ADDENDUM NO. 07

Date: 08.23.2024

**Westfield Washington School Corporation
Westfield Middle School West
Bid Package 02, BI:02 Building Concrete Work and BI:03 Steel and Railing Work
17707 Centennial Road,
Westfield, IN. 46074**

The Hagerman, Inc portion of this Addendum consists of the following information:

1 MEZZANINE LEVEL - UNIT B
 A203B SCALE: 1/8" = 1'-0"

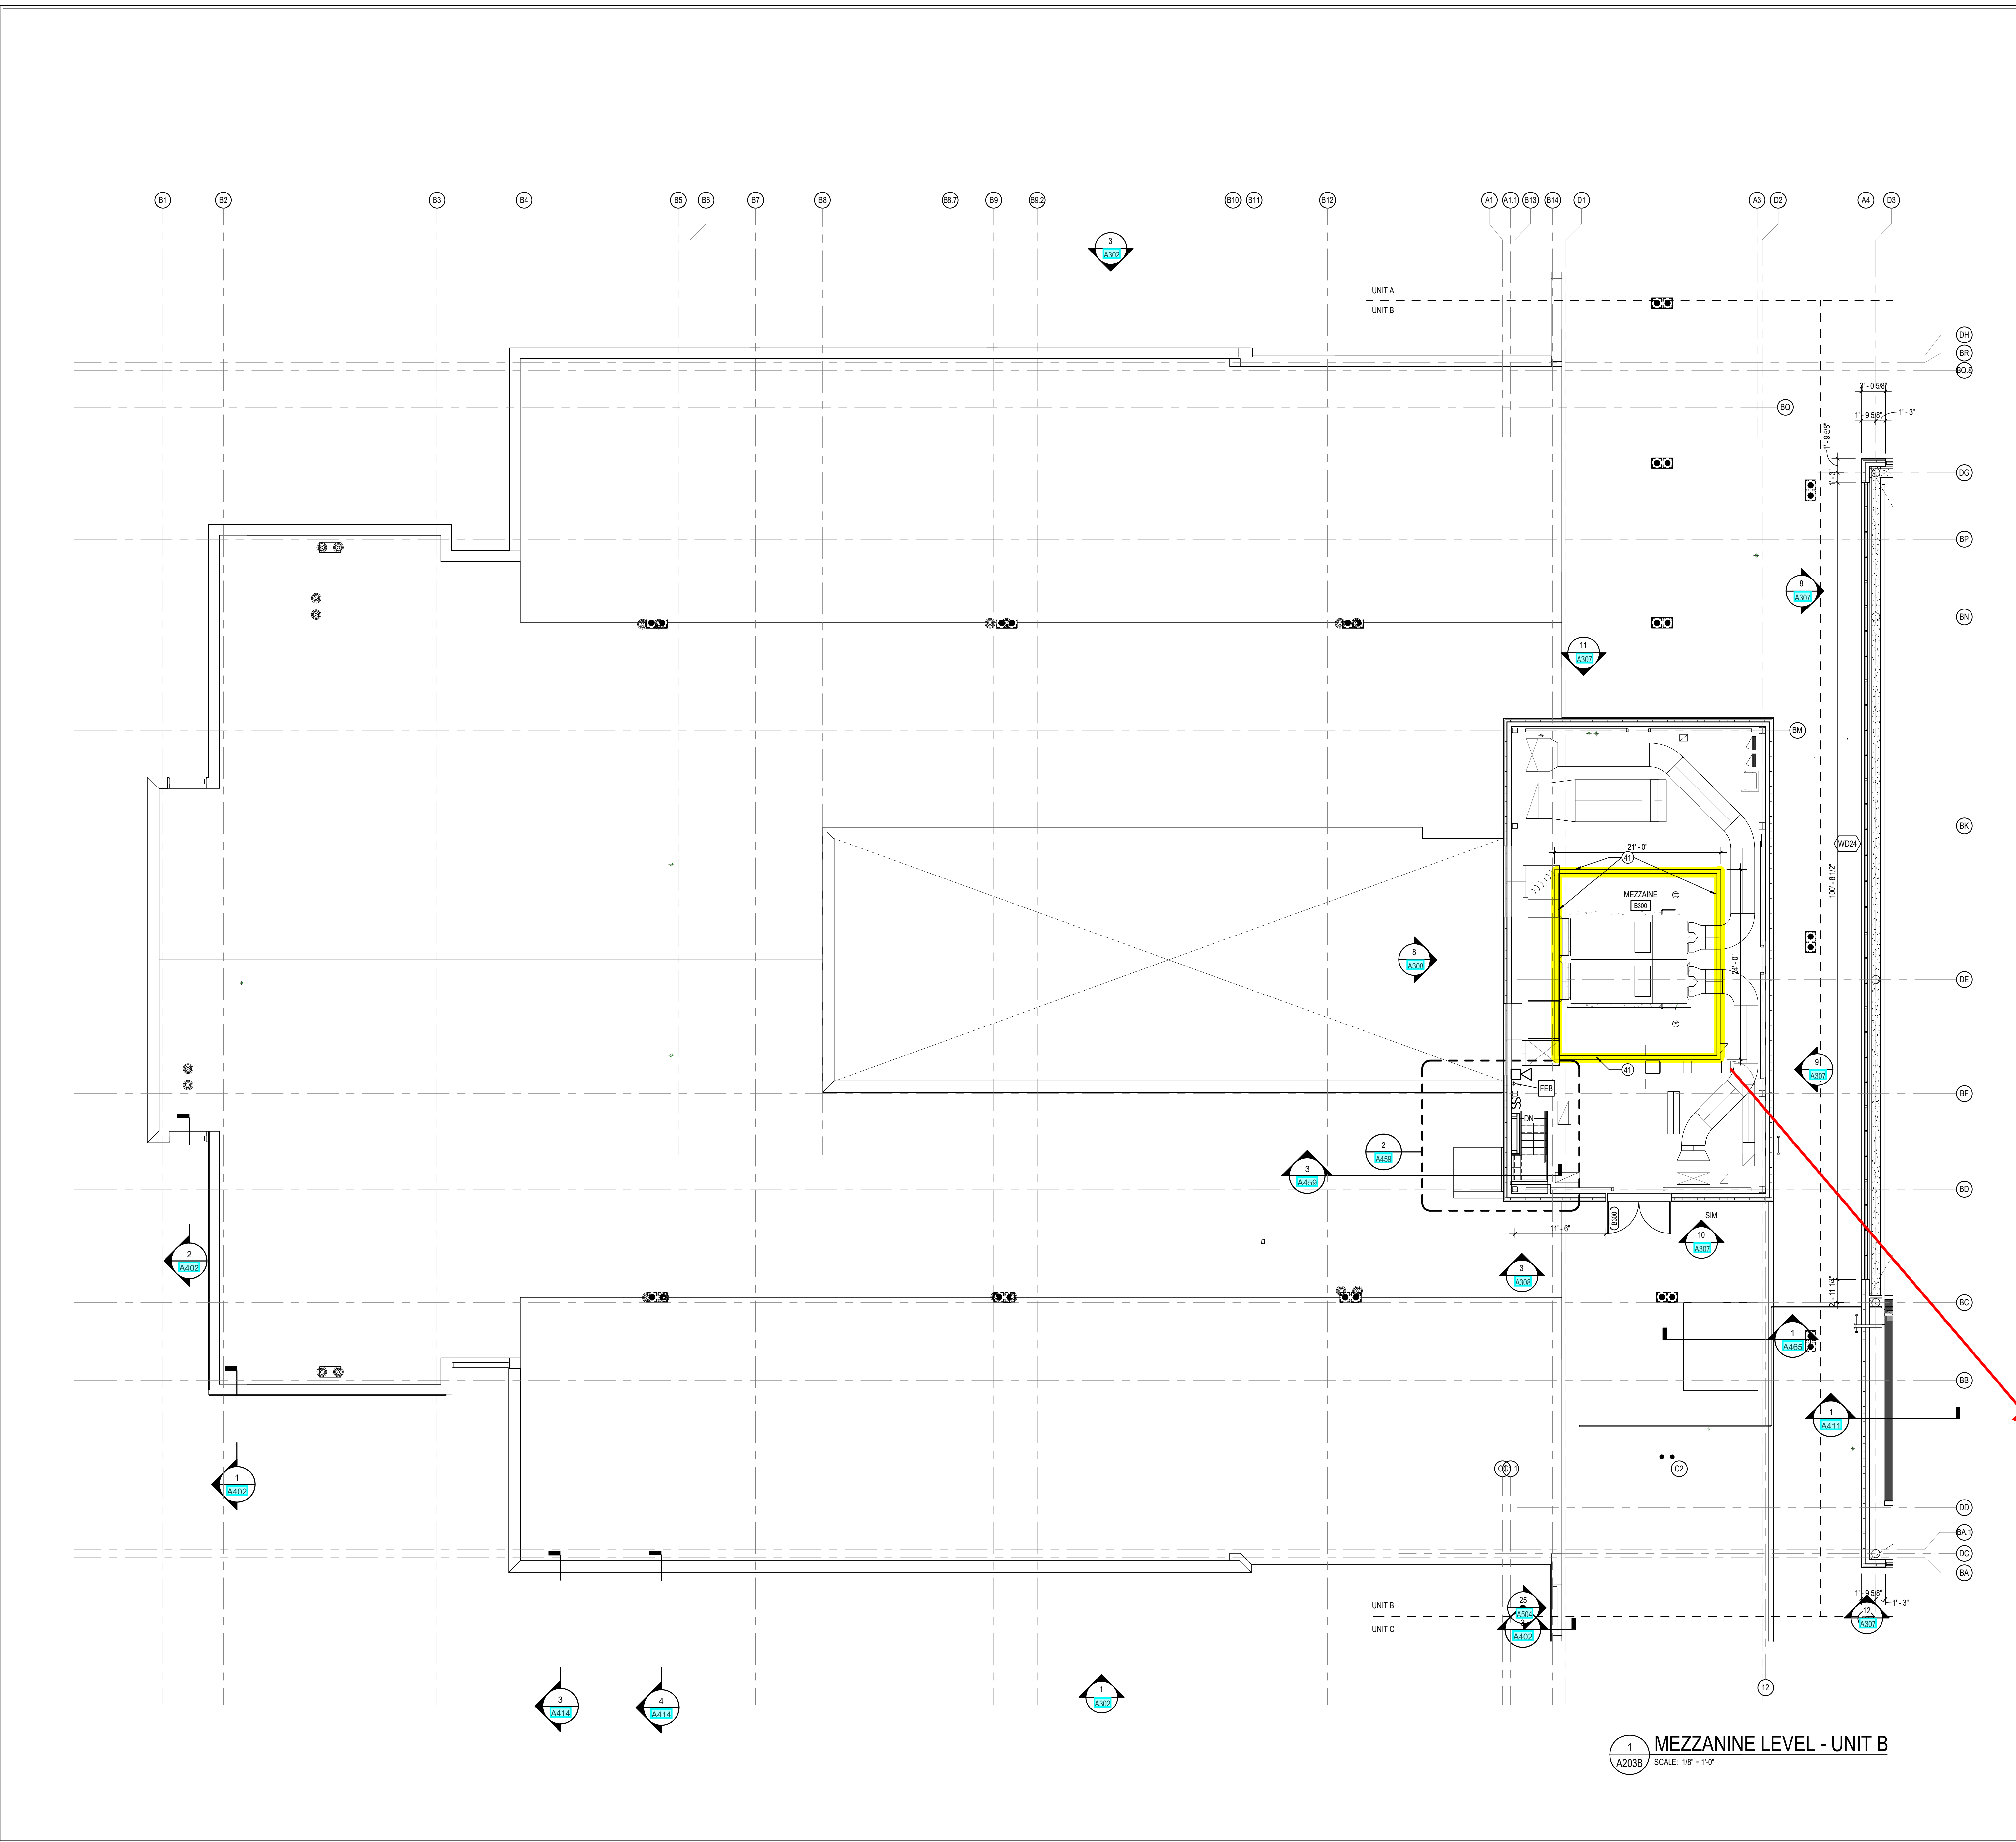
12. A Pre-Bid Meeting was held on 08.20.2024 at 1:00 pm, the sign in sheet is attached for reference.
13. Bid Item #02, Building Concrete Contractor furnish and install the 4" tall by 6" wide concrete curb to the Mezzanine Mechanical Room B300 as shown on the Drawing A203B Dated 08.09.02024 per Note 41, see attached sketch.

2 FOUNDATION PLAN - ENTRY GATES
 SCALE: 1/8" = 1'-0"

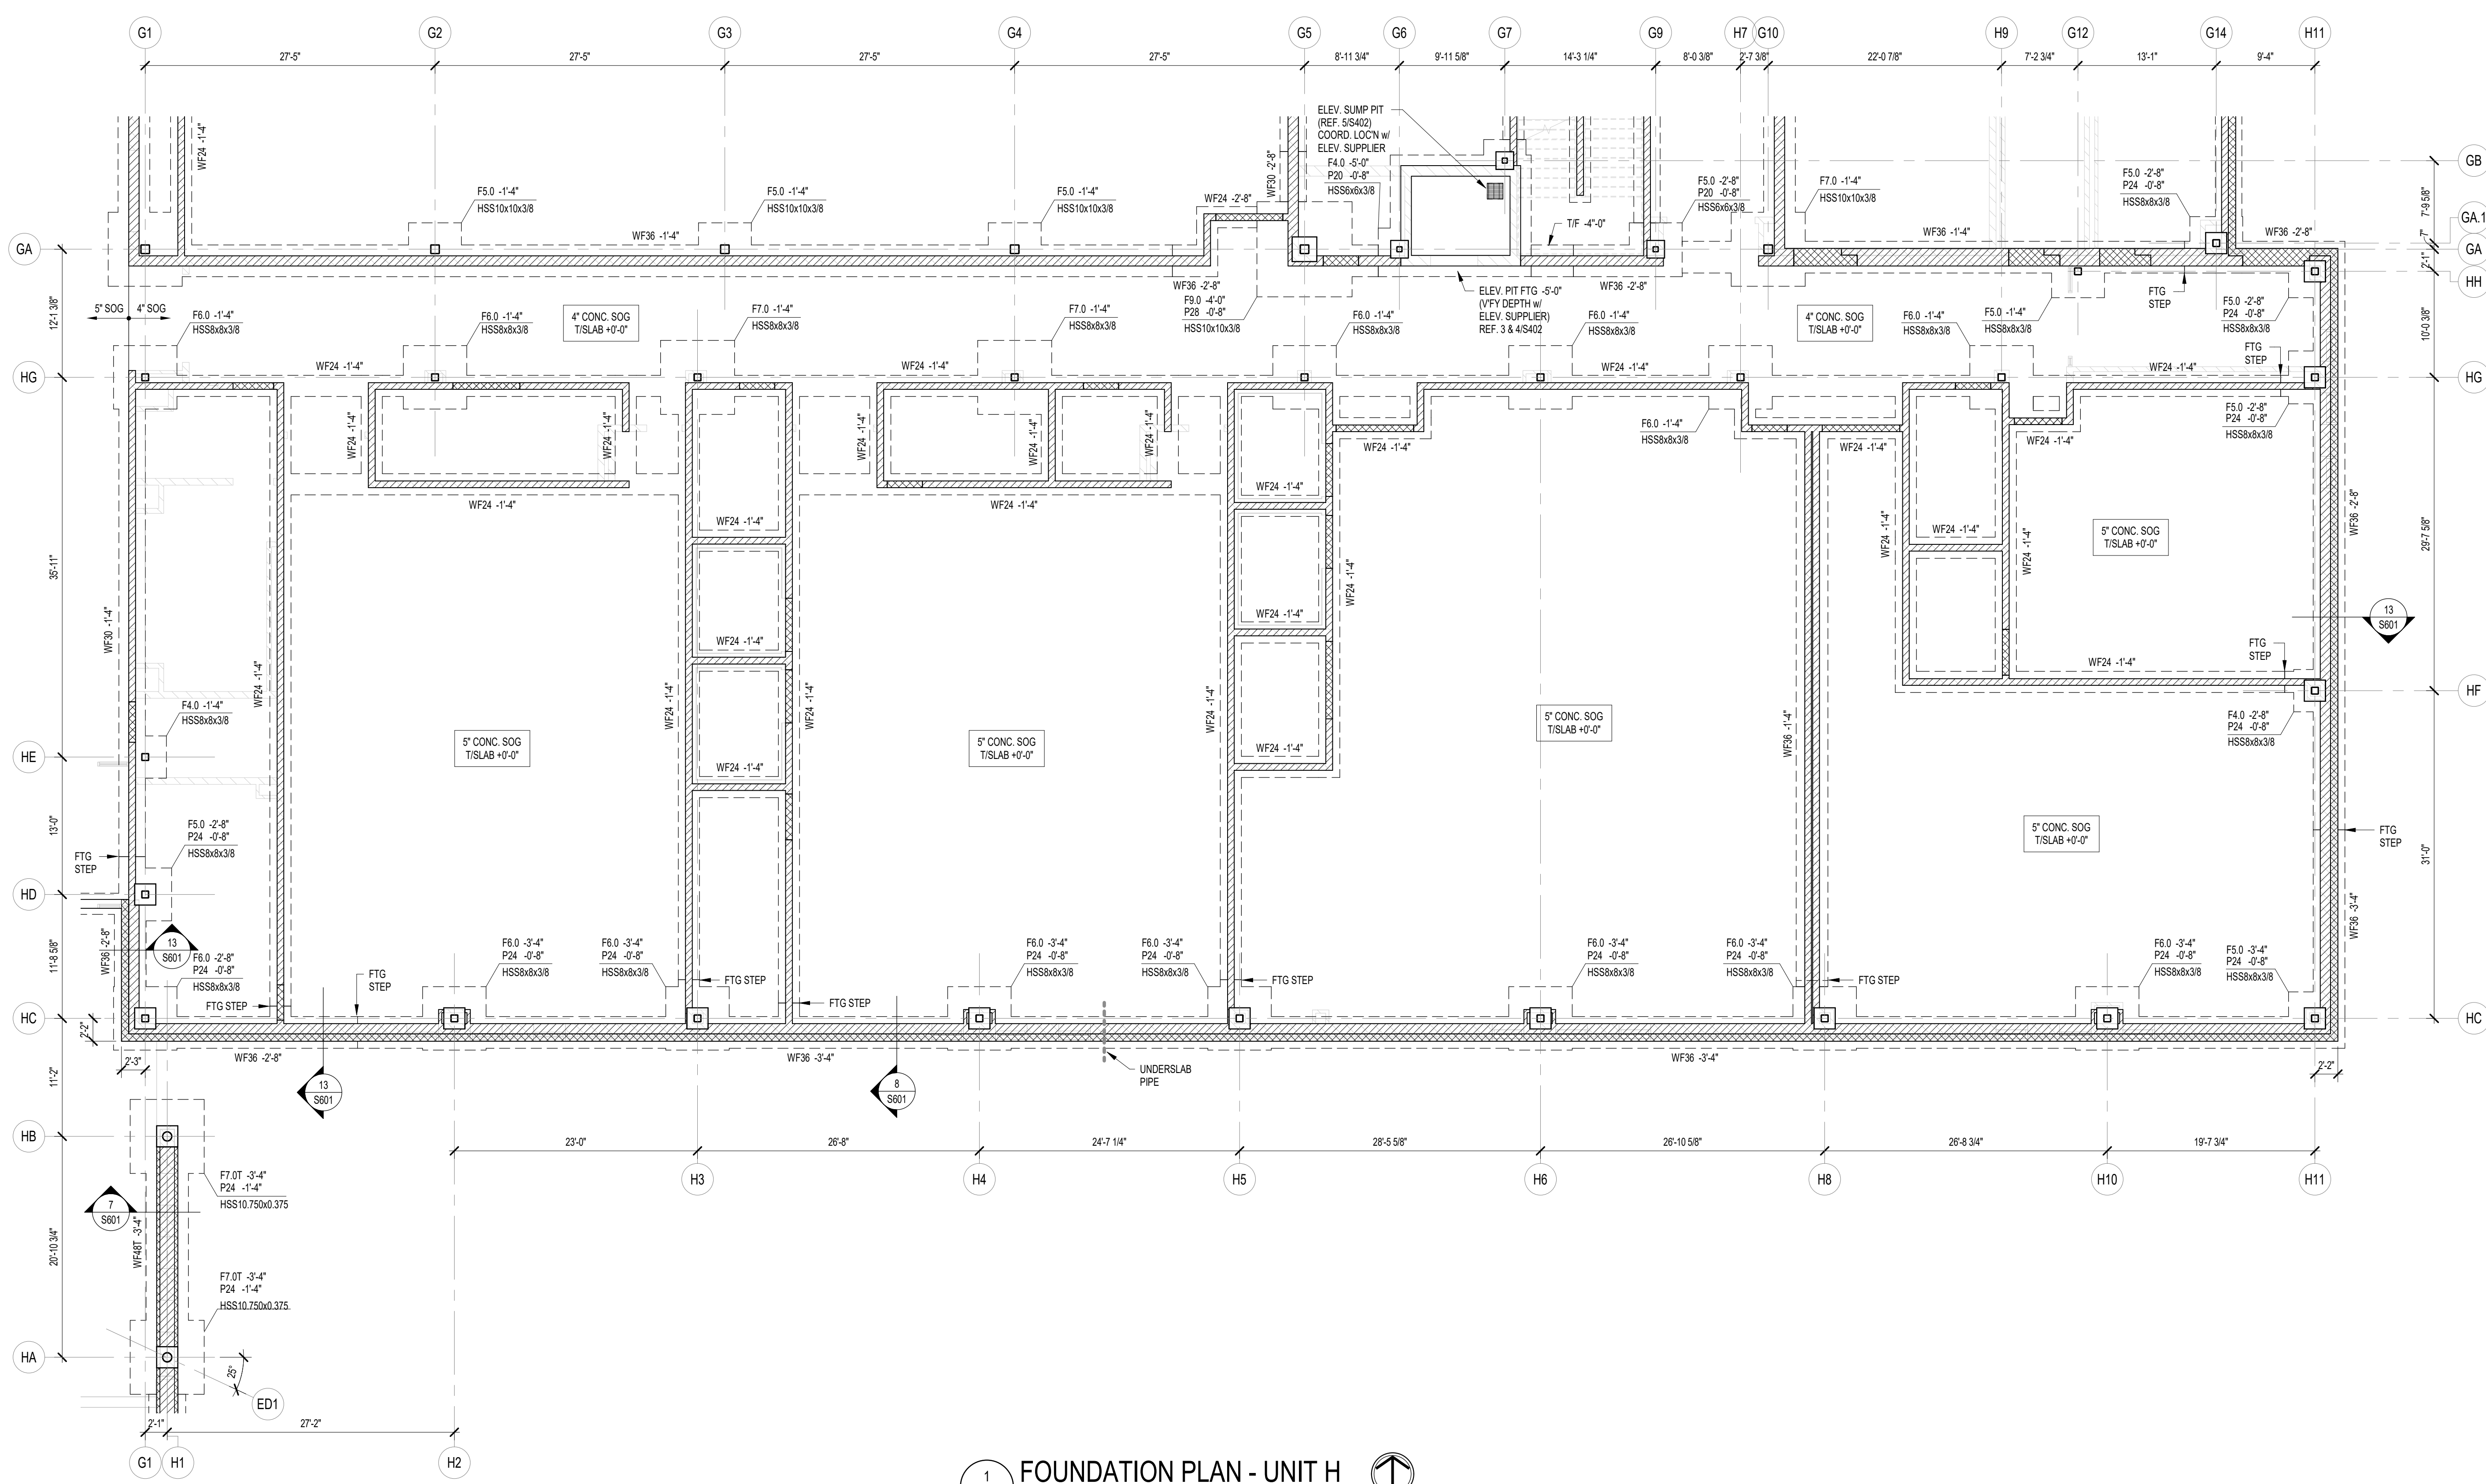
A. Add note to 2/S201H referencing architectural drawings A333 & A334.
